**PLANNING COMMISSION REPORT**  
**Regular Agenda – Public Hearing Item**

PC Staff Report  
1/25/16

**ITEM NO. 6: SPECIAL USE PERMIT; FAST ORDER FOOD WITH DRIVE-IN; 4300 W 24<sup>TH</sup> PLACE (SLD)**

**SUP-15-00521:** Consider a Special Use Permit for approval of a neighborhood commercial shopping area that includes one building to house a *Fast Order Food, Drive-in*, located at 4300 W 24<sup>th</sup> Place. The plan proposes 31,625 sq. ft. of commercial development in five buildings with four drive-in uses indicated. Submitted by Paul Werner Architects, for RPI, LLC, property owner of record.

**Figure 1: Pedestrian Focal Points**

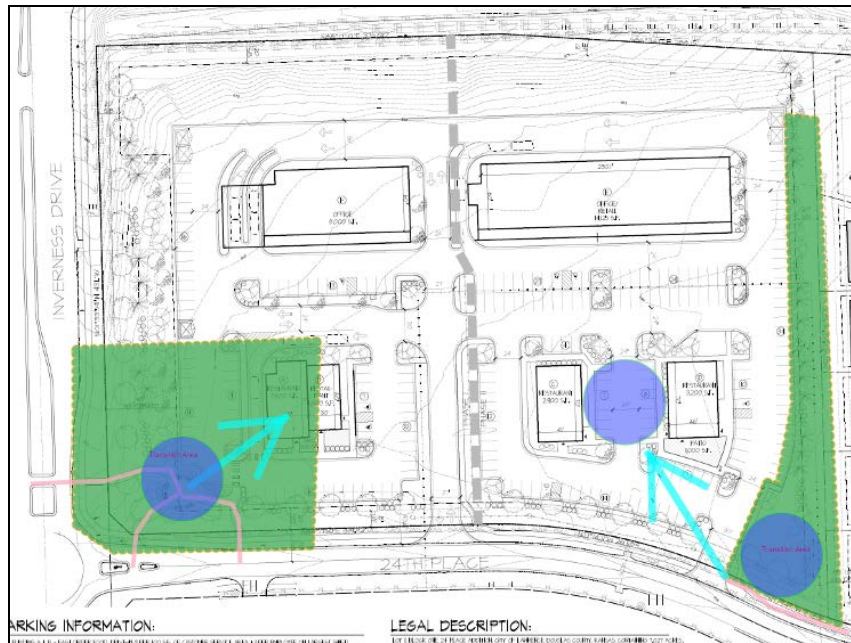
The following graphic highlights the buffer areas, initial pedestrian pathways and focal points of the development. Transition areas at the southwest and southeast corners of the site are not appropriate locations for auto oriented uses (drive-in) in this specific neighborhood context.

**Figure 2: Southwest Corner Development**

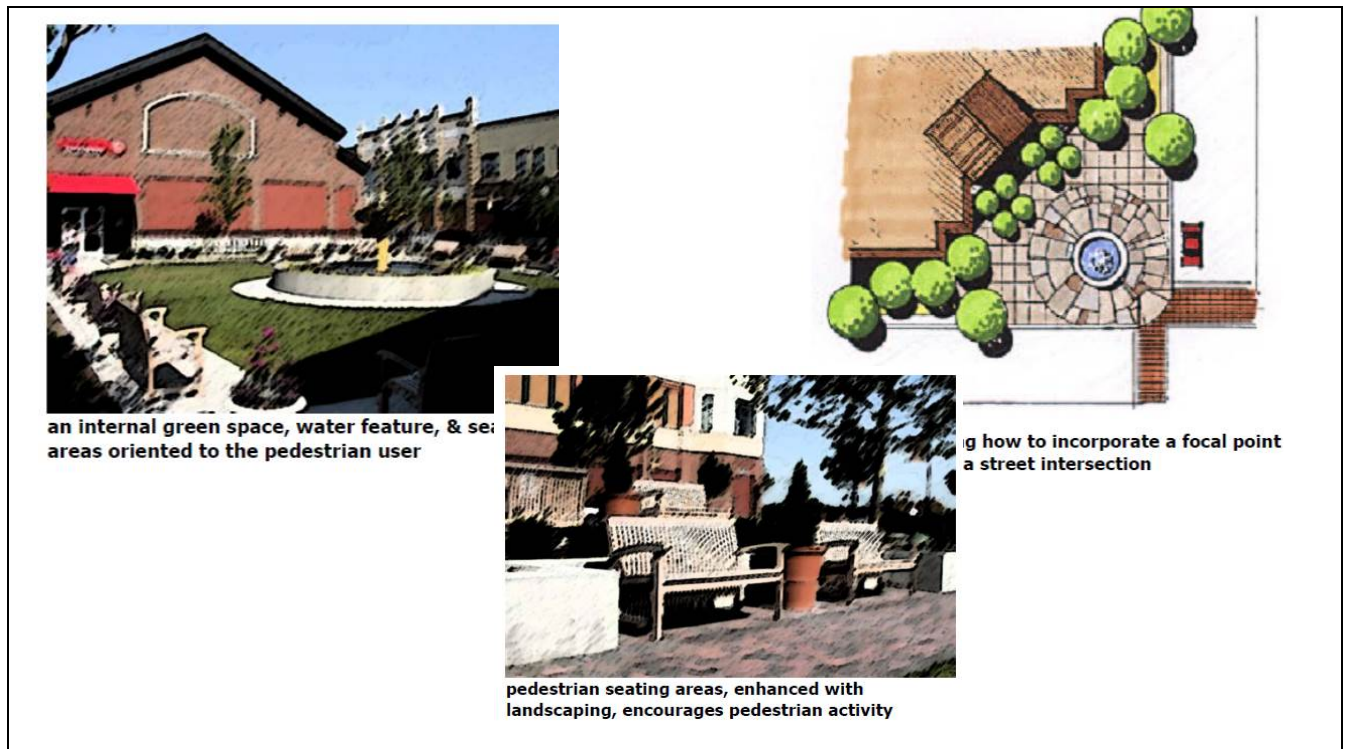
***Pedestrian accessibility and amenities:*** Several pedestrian connections within the development and from the public sidewalks to the development need to be more fully developed. This plan provides a stronger pedestrian amenity at the intersection than has been seen in previous plans; however, this space immediately connects to a parking lot with crossings through a drive-in lane.

Previous development discussions of this property, and specifically the southwest corner of this property, have focused on the need for a wide buffer that provides transition between the residential uses to the west and the commercial uses to the east. These discussions have included mini-park like

**Table 3: Clinton Parkway Street Tree Exhibit**

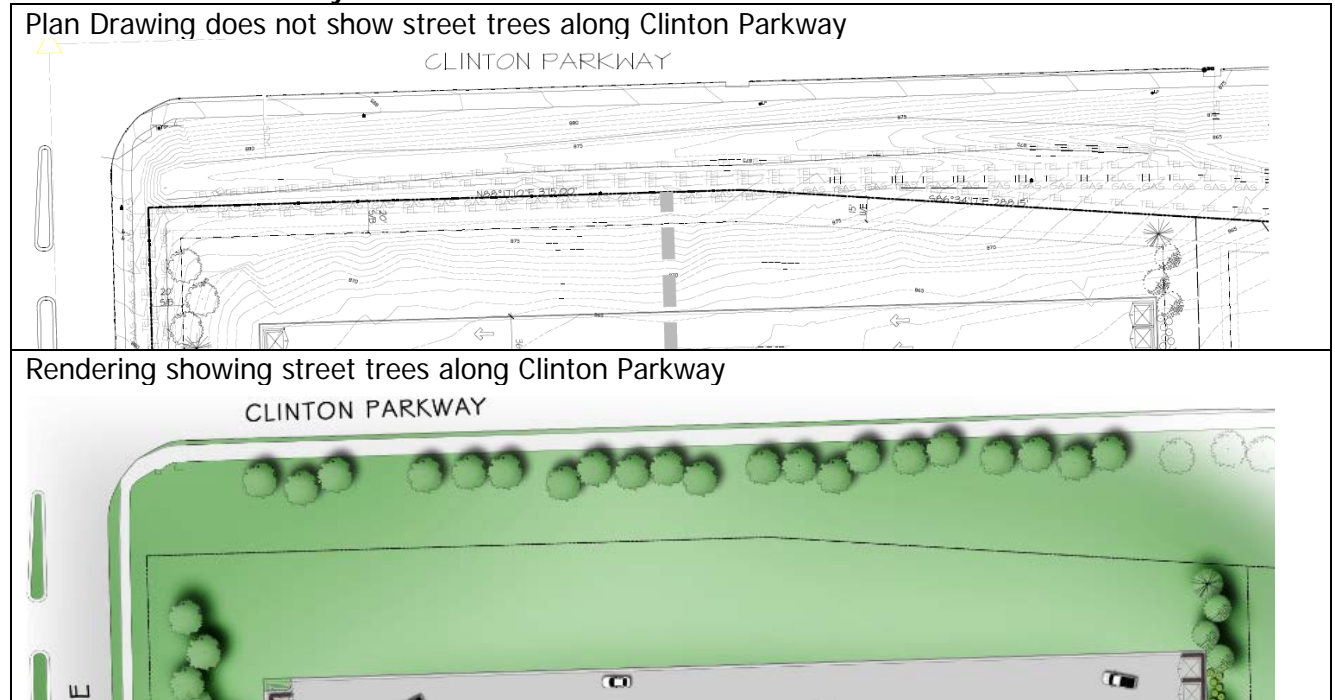
**Street Trees:** The proposed plan does not show the required street trees along Clinton Parkway (within the right-of-way). However, along Inverness Drive and W 24<sup>th</sup> Place, street trees are provided. W 24<sup>th</sup> Place street trees are setback north of an existing utility easement. Staff has confirmed that some utilities are using parts of the easement along the north side of W 24<sup>th</sup> Place. The proposed landscape provides trees, shrubs and berms to accommodate screening and buffering required for this development. The applicant's rendered (colored) drawing shows street trees along Clinton Parkway. The plan must be revised to include the required street trees along Clinton Parkway.

**Clinton Parkway Buffer Yard.** The north side of the property abuts Clinton Parkway. The existing topography includes a 10' hill with the street elevation much higher than the pad site of the buildings. The hill side creates a natural buffer between the proposed use and Clinton Parkway. The rear building facades and service areas are likely to be screened by the natural topography. It is probable that only the rooftops of the buildings will be visible from the public street.

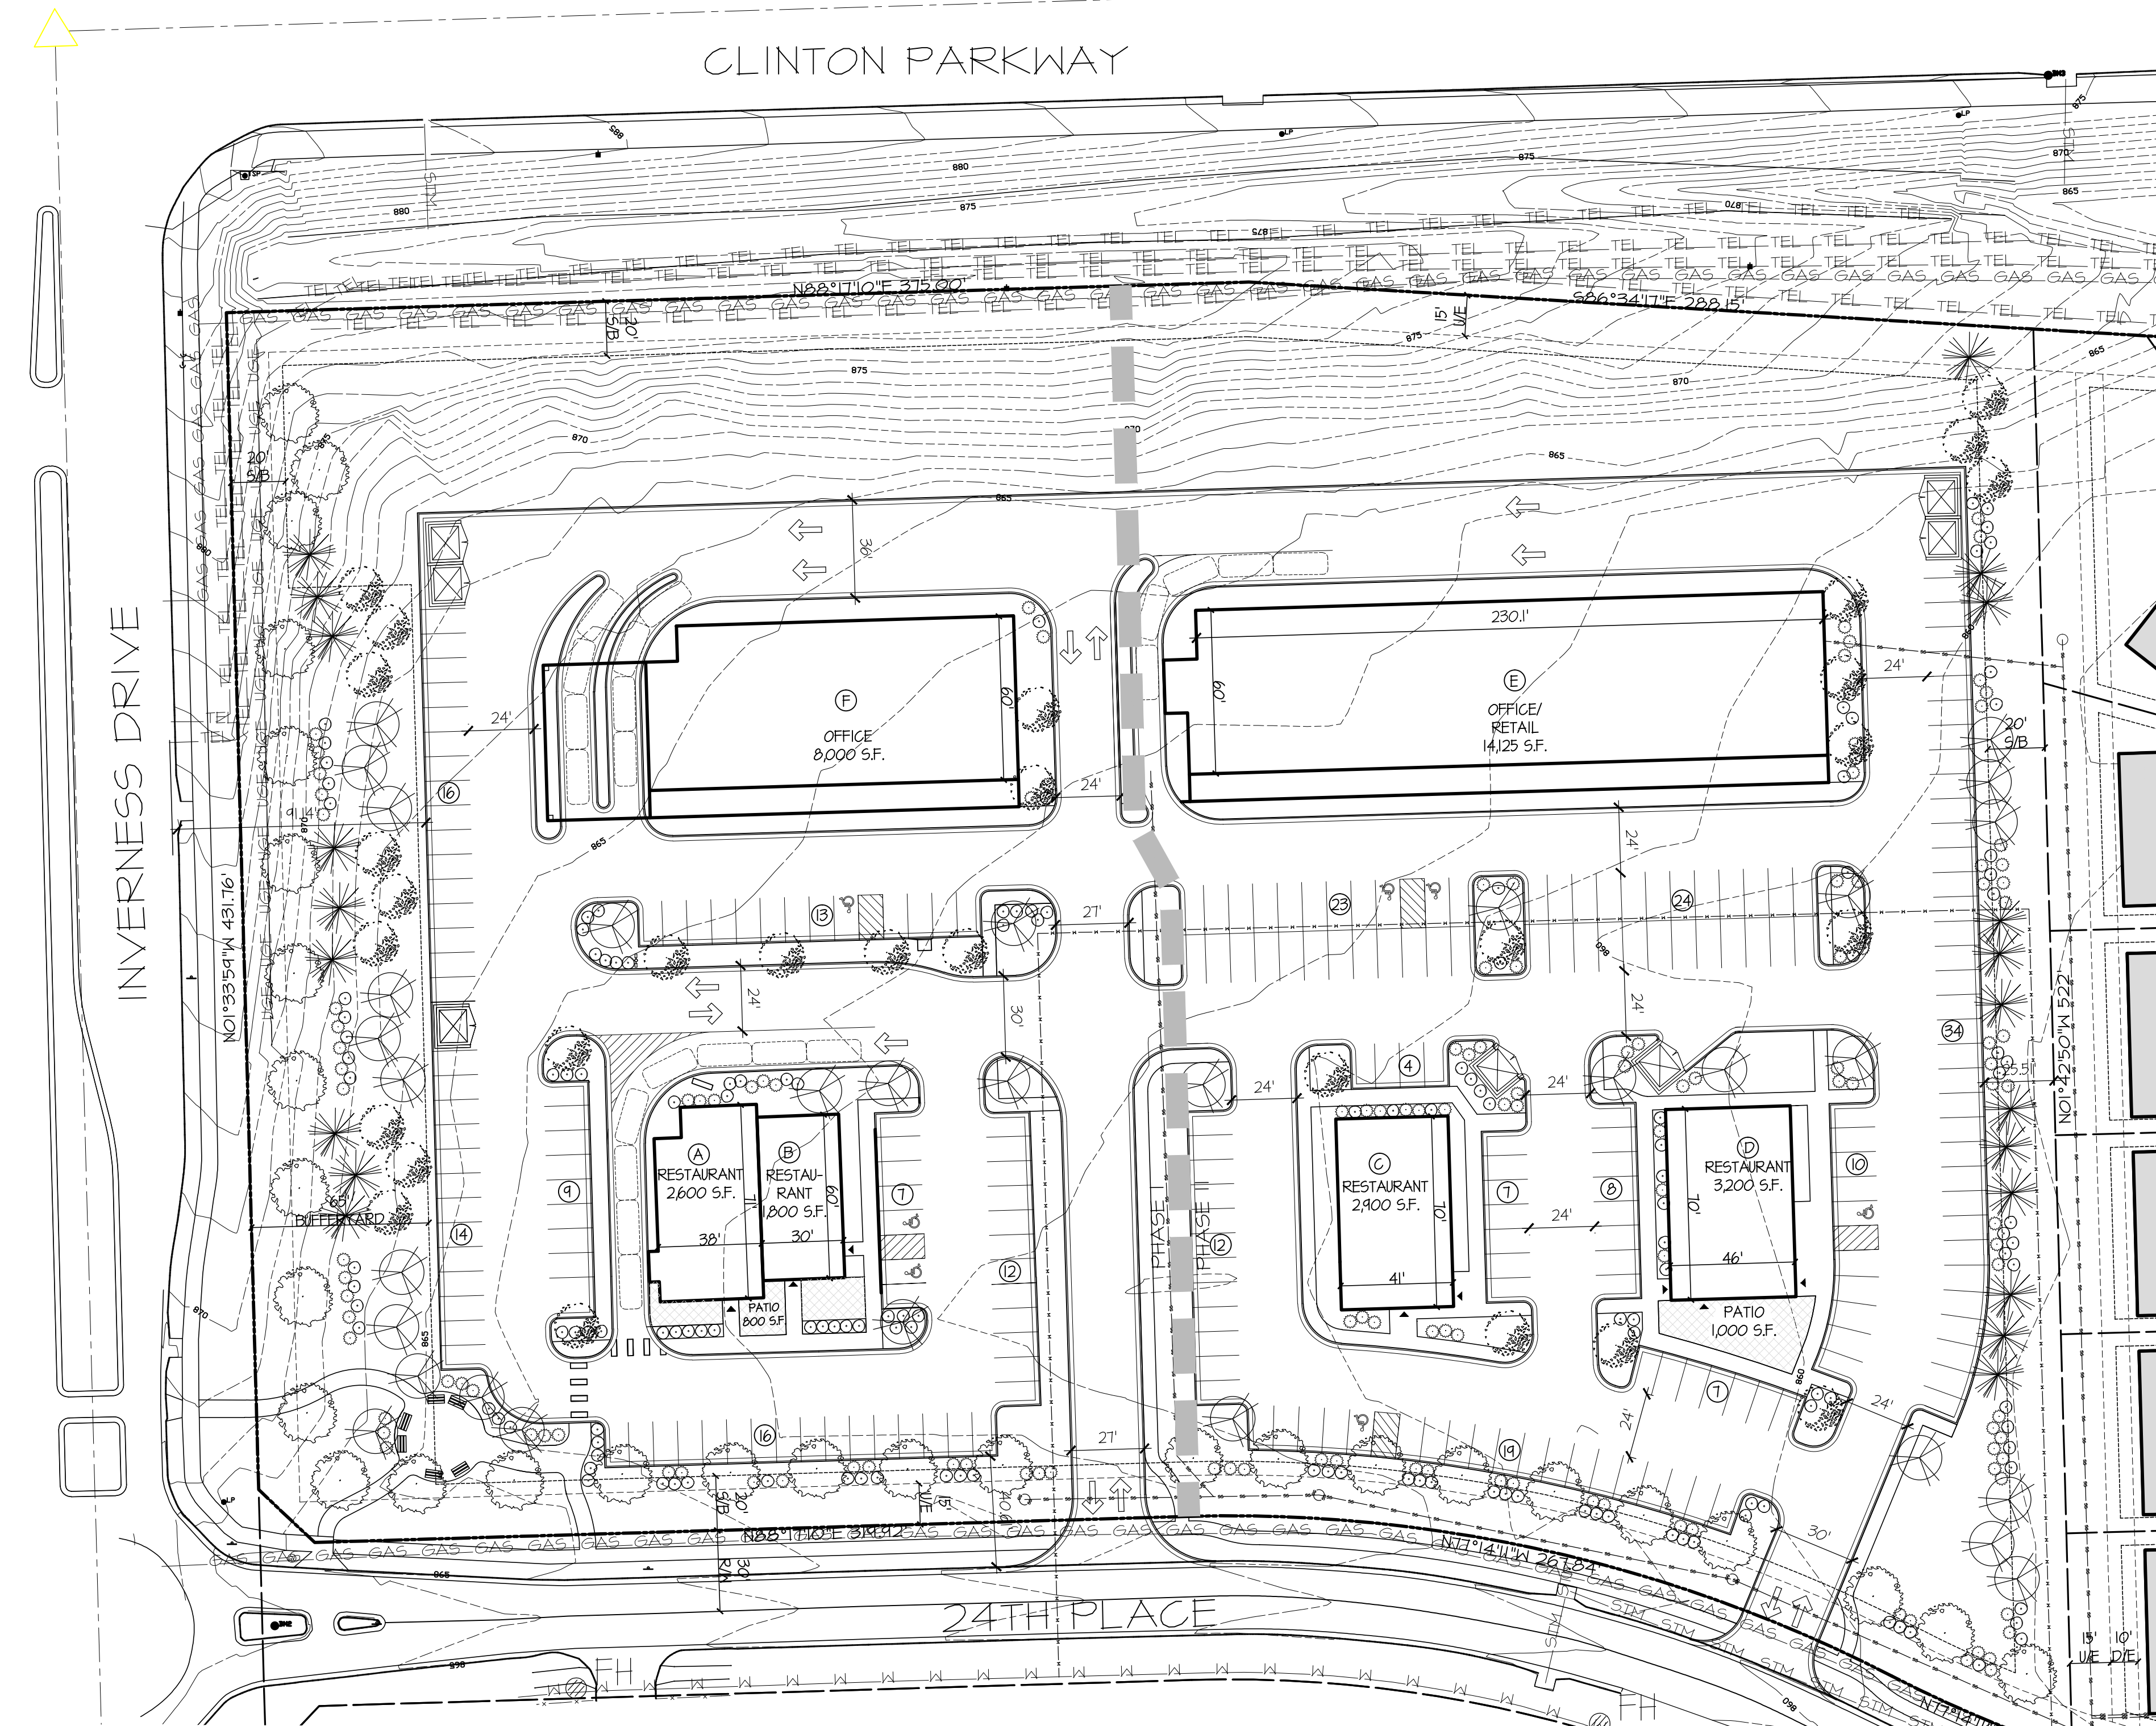
1. Prior to release of the site plan for issuance of a building permit the applicant shall;
  - a. Submit a revised Special Use Permit (site plan) to include building elevations demonstrating compliance with the Commercial Design Guidelines, photometric plan per section 20-1103 for administrative review and approval. This same note shall be included as a note on the face of a revised plan.

2. Provision of a revised site plan to include the following general notes:
  - a. Provision of a note on the face of the plan that limits the number of *Fast Order Food Drive-in* uses for this property to one (1). Any additional *Fast Order Food Drive-in* uses for this property shall require approval of a Special Use Permit prior to construction.

- e. Revised the landscape notes to include street trees required along Clinton Parkway and revise drawing to graphically show the required street trees.

The applicant has not provided a photometric plan at this time. A photometric plan will be required prior to the issuance of a building permit. Staff recommends a note be added to the plan to clarify that a building permit for any part of this development shall not be issued until a photometric plan required per section 20-1103 has been submitted for review.
